Amendments to the Drawings:

TITLE: ACTIVE THERMAL CONTROL SYSTEM WITH MINIATURE
INVENTOR: Samer KABBANI et al.
SERIAL NO.: 10/758,209
ATTORNEY DOCKET NO.: 047589-0167

FIG. 3

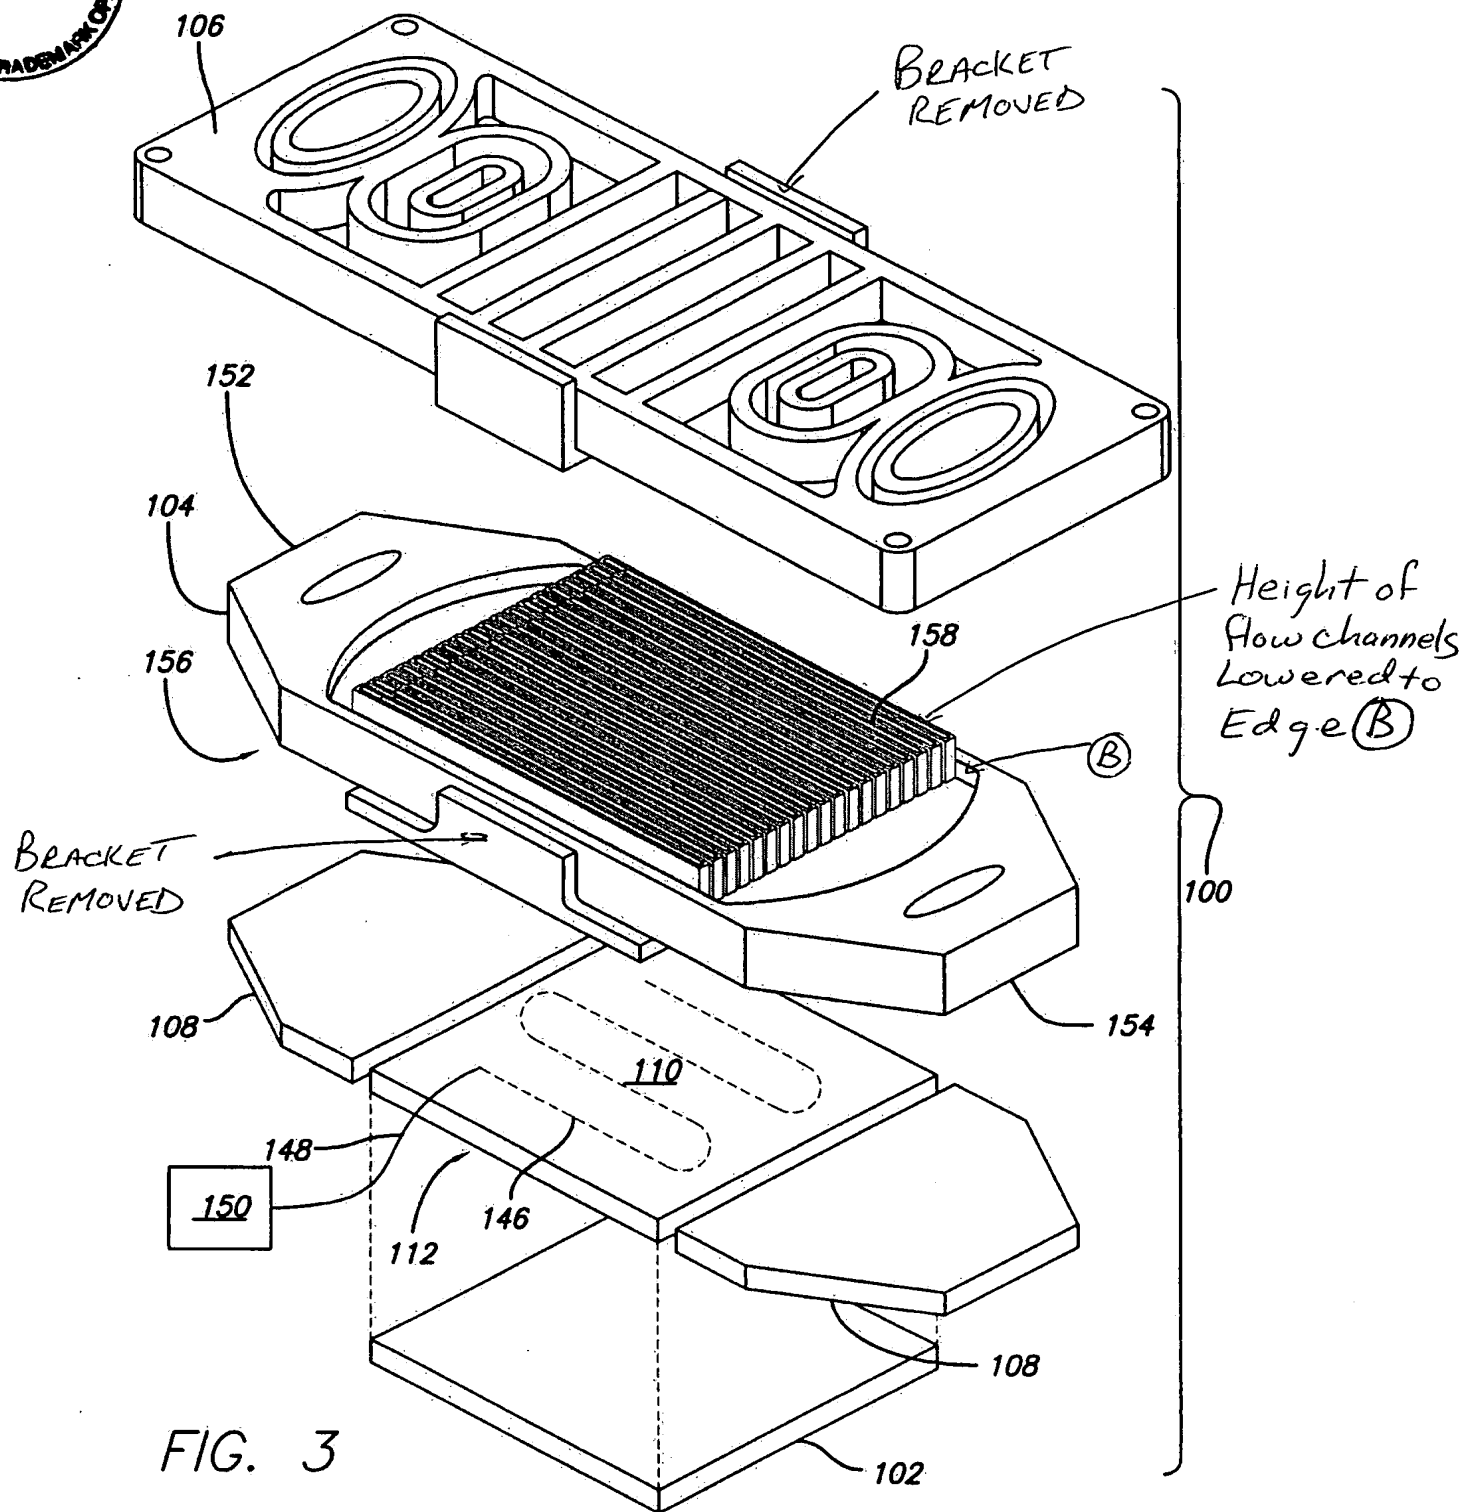
The specific changes which have been made to Figure 3 and 5 are to remove the unlabeled brackets supporting elements 104 and 106 and to conform the height of the flow channels 124 and 140 to the thickness of heat sink 104.

Figs. 3 and 5 both include unlabeled brackets shown as supporting elements 106 (the cover) and 104 (the heat sink). In Figs. 4, 6, and 7, however, these unlabeled brackets are not shown, and thus the brackets do not interfere with the assembly and sealing of the device 100. More important, there is no description of these brackets anywhere in the specification of the present application.

Part 158 actually refers to a side of the heat sink 104, not the flow channels. Rather, as shown in Fig. 5 and described in ¶¶ [0035-0036], the flow channels correspond to first flow channels 126 and second flow channels 140.

By this Amendment, Applicants have amended Figs. 3 and 5 to remove the brackets, which are neither labeled in the figures nor described in the specification, from elements 106 and 104. Applicants submit that these amendments are supported by the specification and by the arrangements shown in Figs. 4, 6, and 7, and therefore submit that these amendments to Figs. 3 and 5 do not constitute new matter.

By this Amendment, Applicants have amended Figs. 3 and 5 to make clear that the flow channels 126, 140 do not interfere with the assembly and sealing of the device 100. Applicants submit that these amendments are supported by the specification and by the arrangements shown in Figs. 4, 6, and 7, and therefore submit that these amendments to Figs. 3 and 5 do not constitute new matter.
